Product Change Notification

Forge/Anvil Startup Performance on Early Revisions

PCN Number:	CTIU-00073
Revision:	0.00
Issue Date:	2023-11-27
Effective Date:	2023-11-27

1 Product Identification

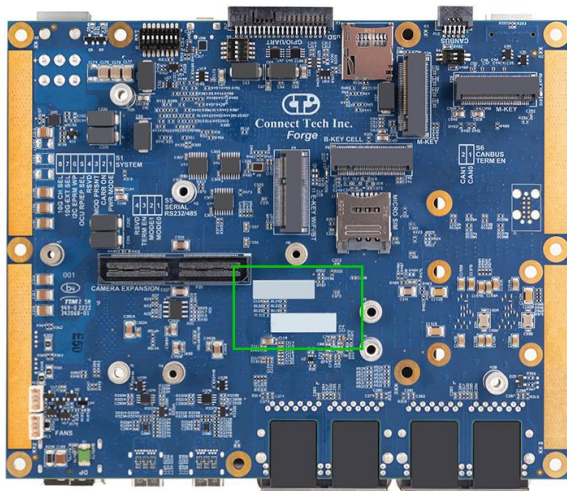
Connect Tech has identified certain edge cases and environmental conditions that may affect the startup performance of the Jetson AGX Orin module used on early revision Forge/Anvil products.

This startup performance issue has been ratified in later revisions of the PCBA for the Forge/Anvil products. Earlier revision PCBA's identified by the serial number ranges above can have this issue resolved via an ECN fix applied by Connect Tech Inc.

If you wish to have this ECN applied to your product, please [contact support](#) to get an RMA issued to have the ECN fix applied.
